# SITE SERVICING AND SWM STUDY MEMORANDUM

SUBJECT: Proposed Amendment to 129 Main Street Site Plan Application  
City File Number: D07-12-10-0196

OUR FILE: DSEL Project No.15-813

SHEET TITLE:  
**SITE PLAN**

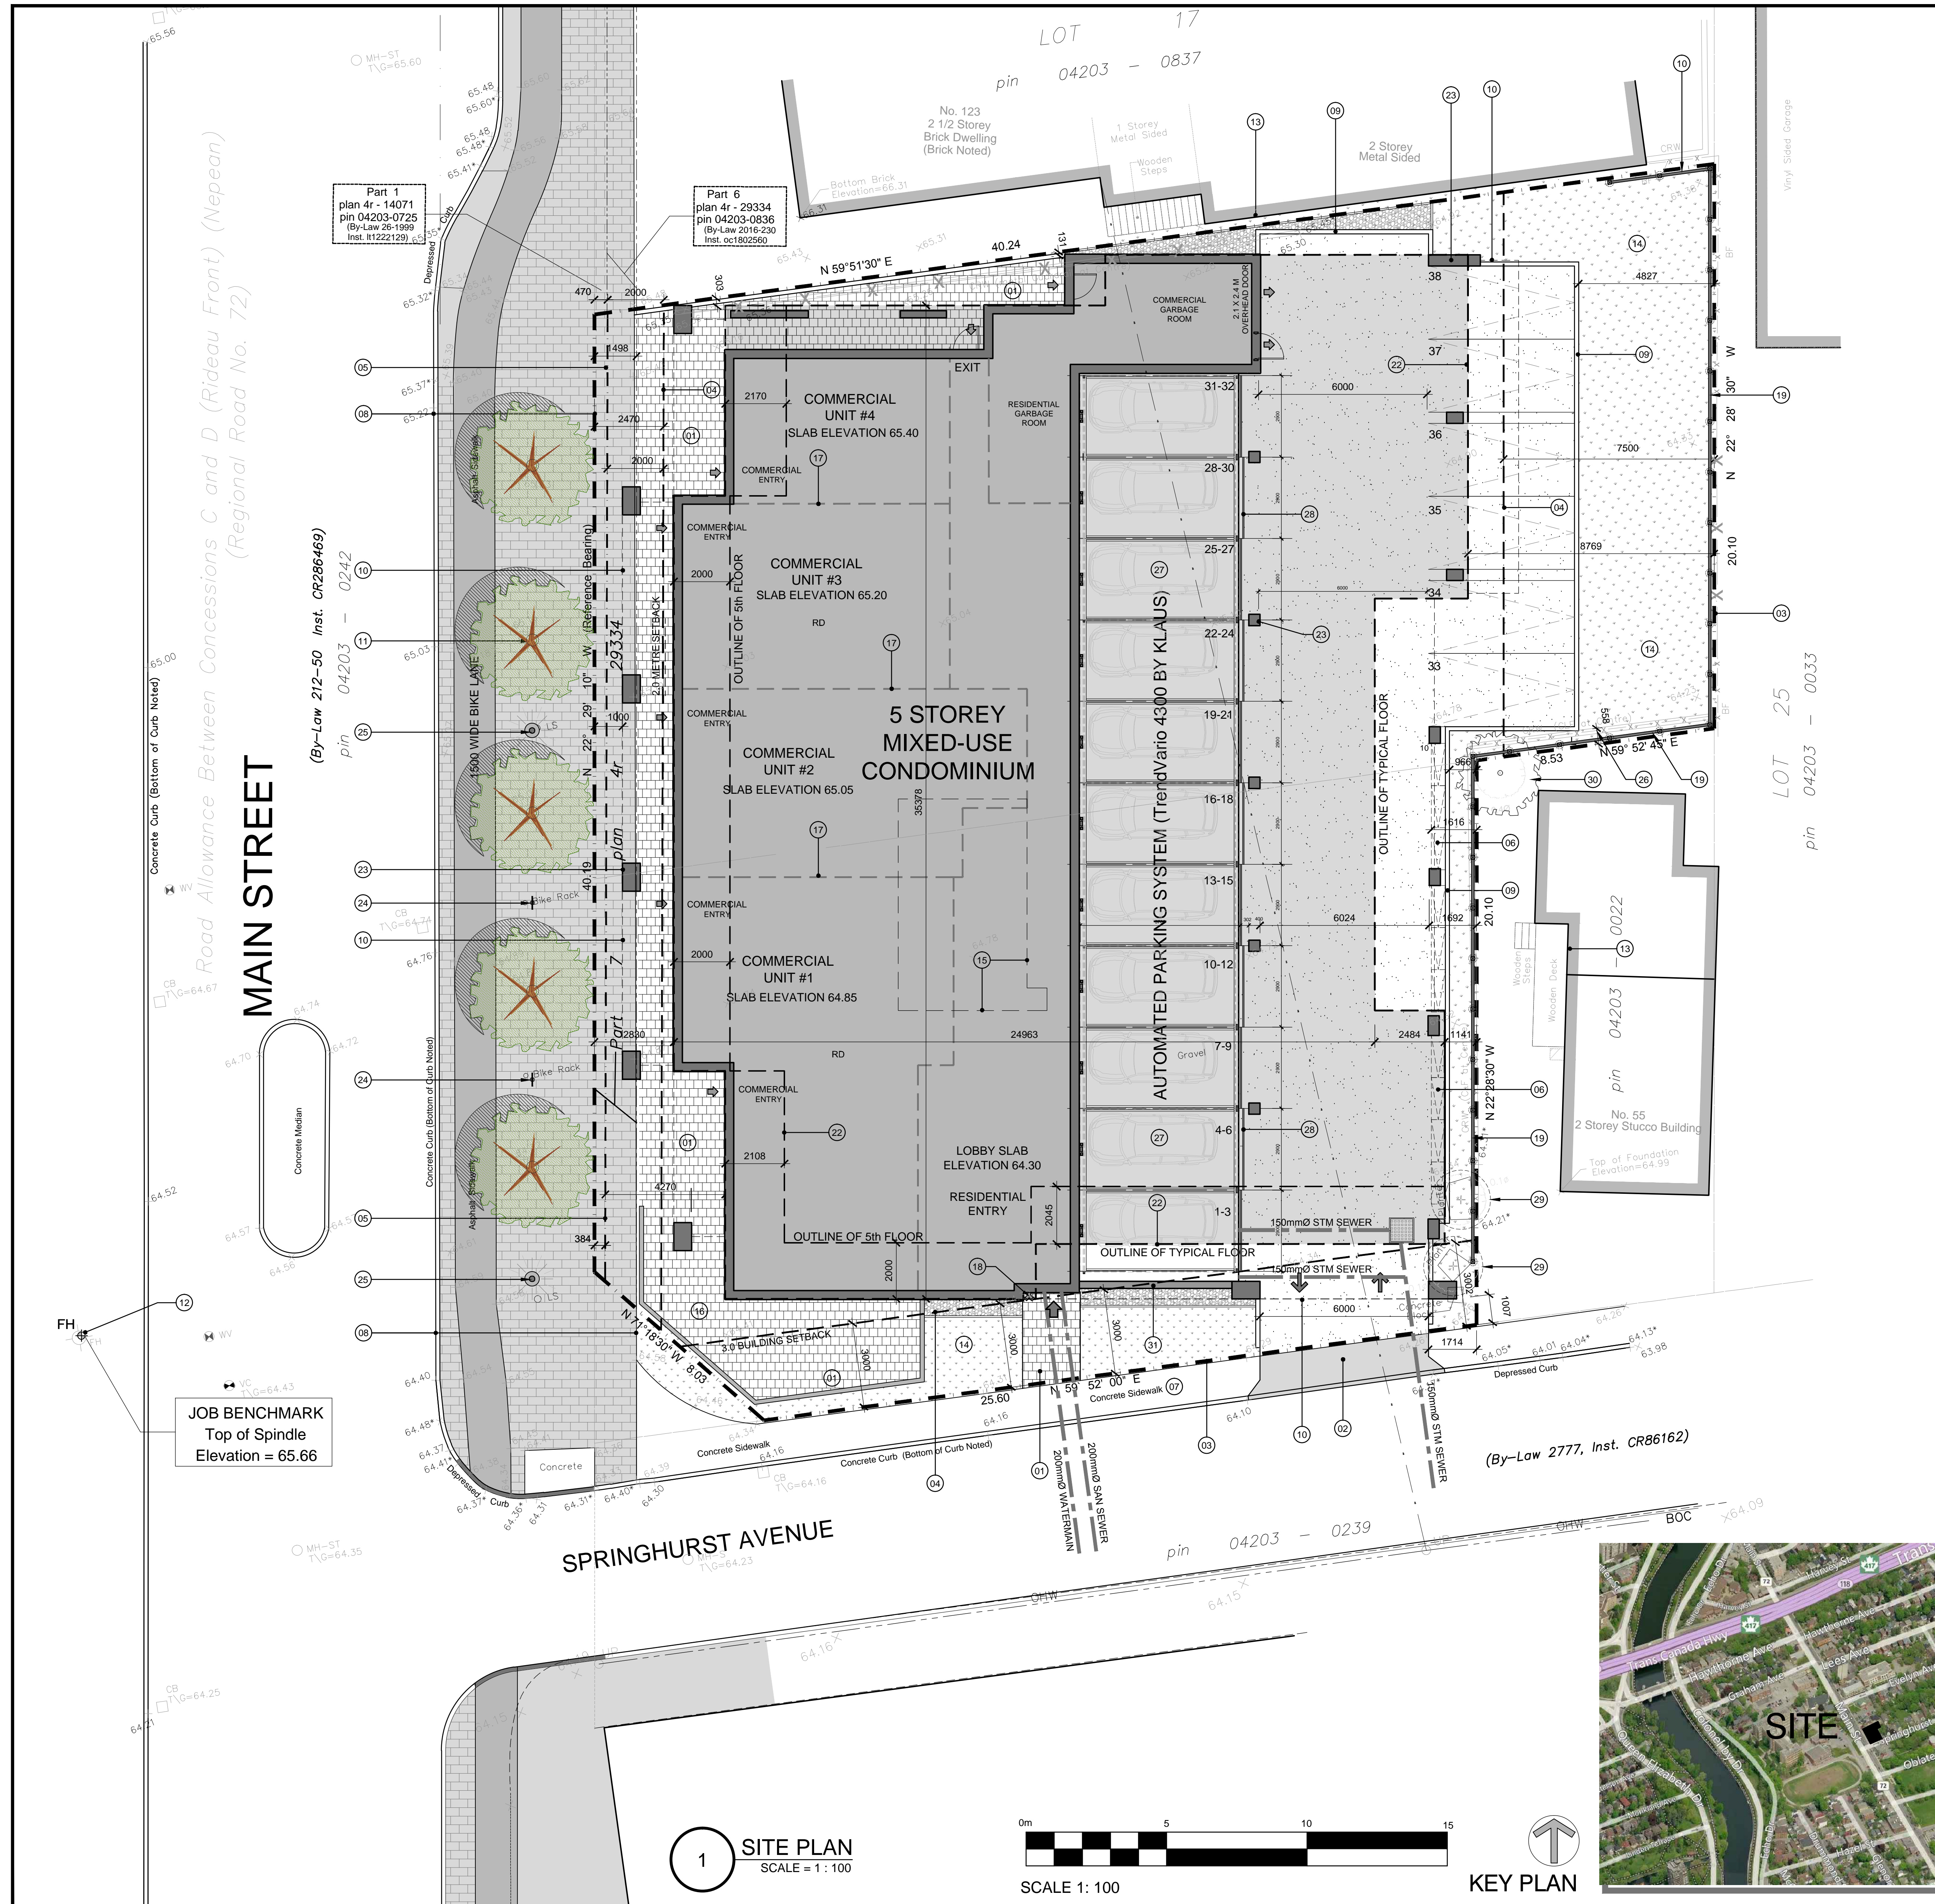
at 129 Main Street (D07-12-10-0196). Please see proposed amended site plan (**SP-1**) dated September 24<sup>th</sup>, 2018, included along with this memo.

The previously approved Site Plan proposed **32** residential units and **446 m<sup>2</sup>** of commercial space. The updated Site Plan proposes a revised building design, consisting of **46** residential units and **300 m<sup>2</sup>** of commercial space.
